BEFORE THE ELECTRIC GENERATION AND TRANSMISSION SITING BOARD

ELECTRONIC APPLICATION OF)
THOROUGHbred SOLAR, LLC FOR A)
CERTIFICATE OF CONSTRUCTION FOR)
AN APPROXIMATELY 50 MEGAWATT) Case No. 2022-00115
MERCHANT ELECTRIC SOLAR)
GENERATING FACILITY IN HART)
COUNTY, KENTUCKY PURSUANT TO)
KRS 278.700 AND 807 KAR 5:110.)

**THOROUGHbred SOLAR, LLC'S RESPONSES TO THE KENTUCKY
ELECTRIC GENERATION AND TRANSMISSION SITING BOARD'S
FIRST REQUEST FOR INFORMATION**

Thoroughbred Solar Post-Certificate Schedule

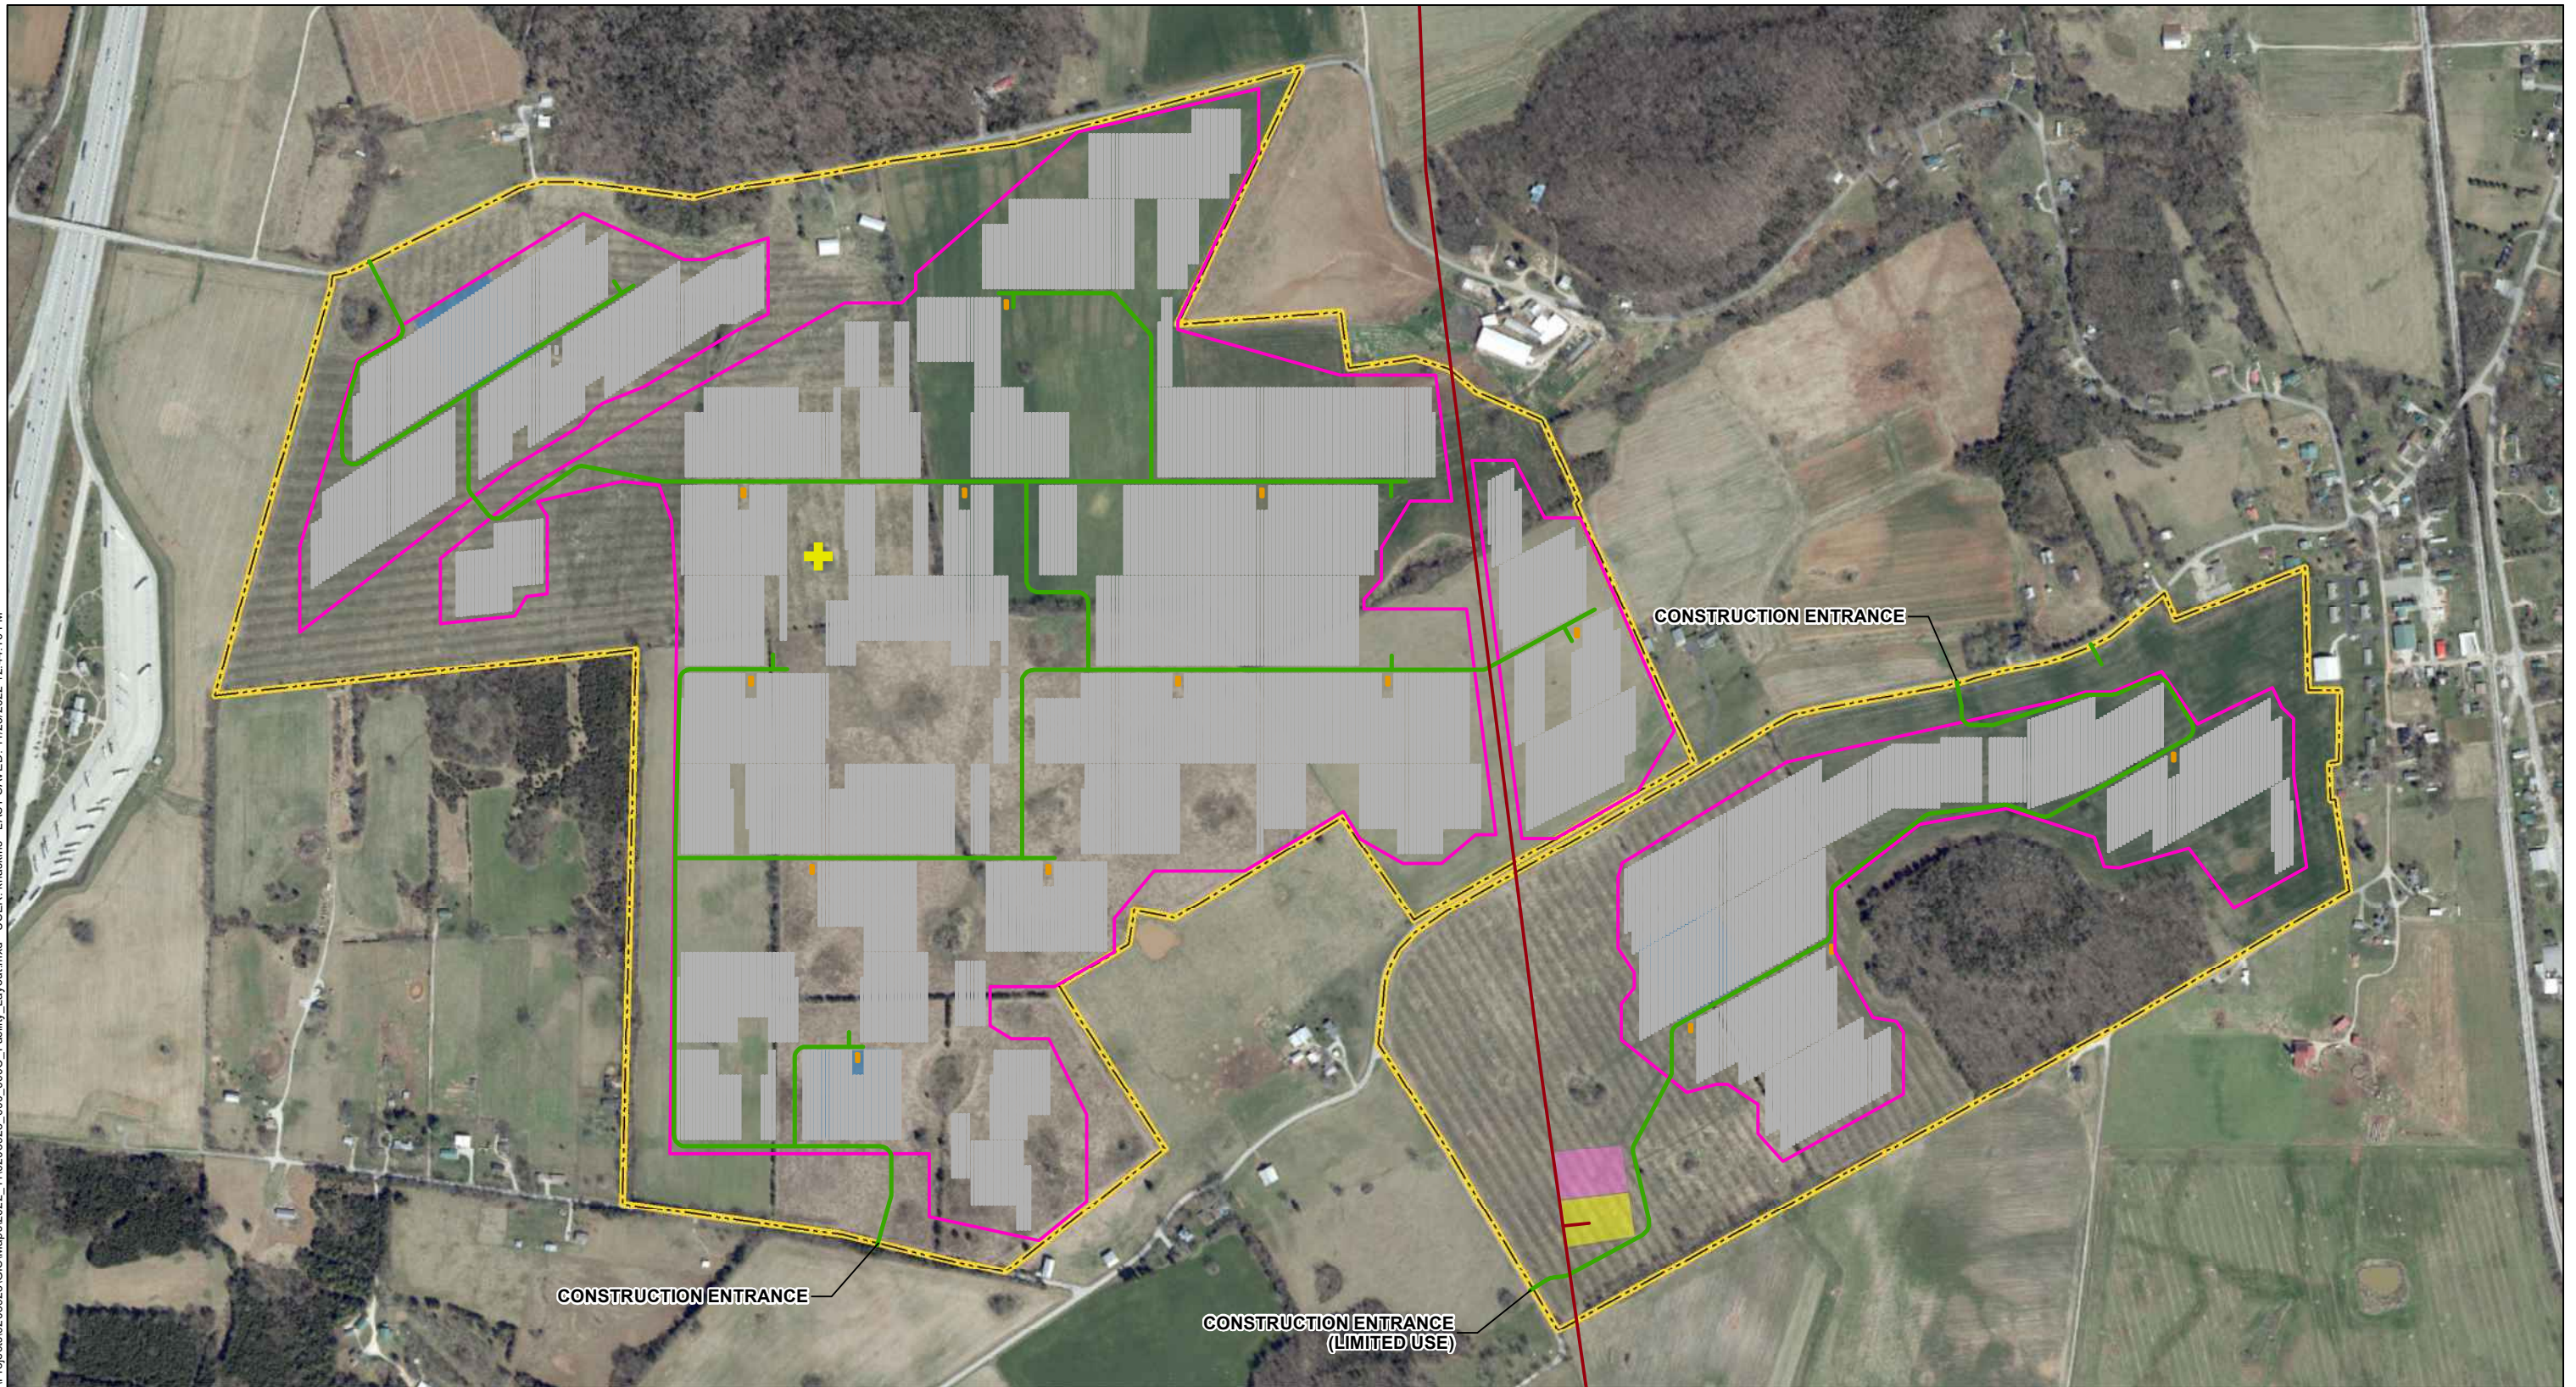
3. Provide a schedule for the project, starting from the receipt of the proposed certificate for construction to the completion of the project. Include the length of each construction phase.

RESPONSE: The current Project construction schedule, including the anticipated length of each construction phase, is set forth in the graphic attached as Exhibit B.

**Exhibit C
Facility Layout**

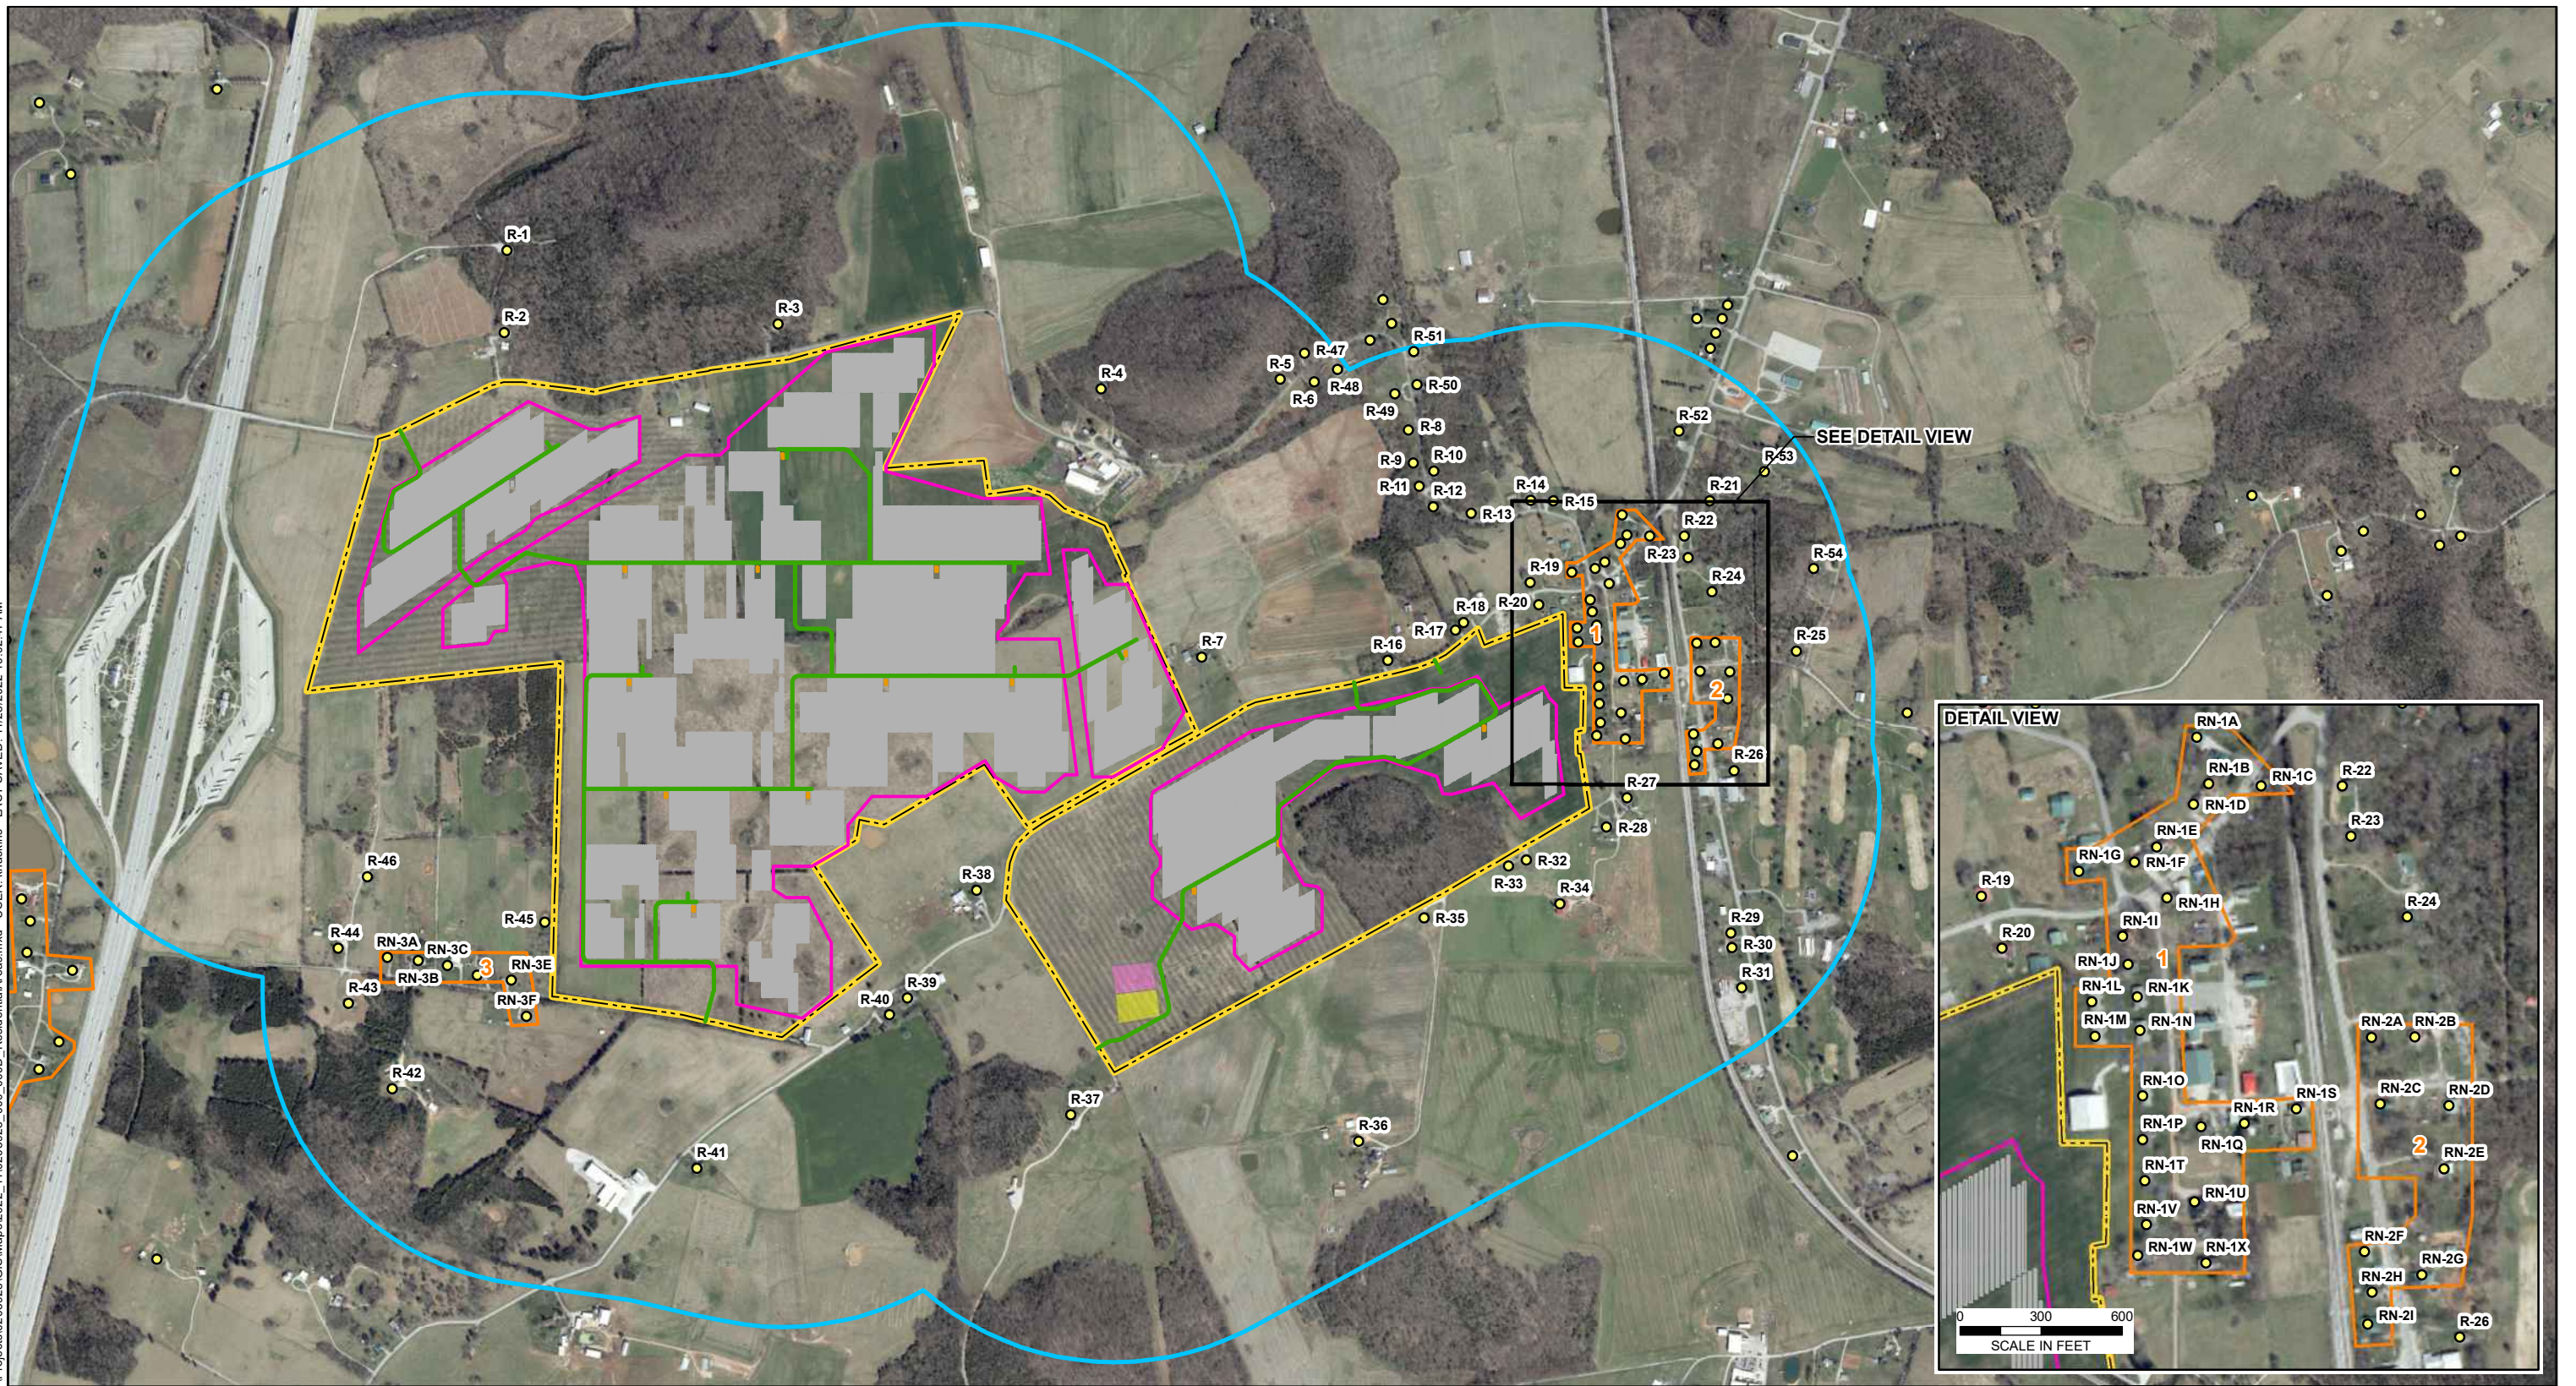
7. Provide a site map that includes all site entrances, substation, panel locations, laydown areas, gen-tie to the EKPC transmission line, and the existing EKPC 69 kV transmission line. Include in the site map a notation regarding entrances to the project that will be used for construction but not operations of the project.

11. Refer to the SAR, Section 2.4.1.
 - a. Identify the cemetery on the site plan.
 - b. Explain who owns the cemetery and is responsible for its maintenance.
 - c. Explain how access will be provided to the public for the cemetery.

RESPONSE: The map provided in the attached Exhibit C adds the existing EKPC 69 kV transmission line, the gen-tie to the EKPC, and notations regarding plans for use of the various entrances to Figure 5 from the SAR. Please note that Rowletts Cave Spring Road is not intended for construction delivery or equipment use, and that the limited use construction access off of Johns Lane is intended for construction of the substation/switchyard only.

RESPONSE: The figure provided in Exhibit C also indicates the location of the cemetery. The small cemetery is on private property owned by the Isaacs family, but predates their ownership. No specific maintenance has been occurring and no additional measures are planned, although the presence of the tree grove surrounding the headstones indicates that farming practices have avoided encroachment into the cemetery. When asked, no member of the Isaacs family was aware of any request for or need for public access to this cemetery. However, the Project layout has similarly avoided encroachment on the tree grove and cemetery, and – as can be seen in Exhibit C – access from Project internal roadways will be readily possible. The Project will facilitate requests for access, if any are received.
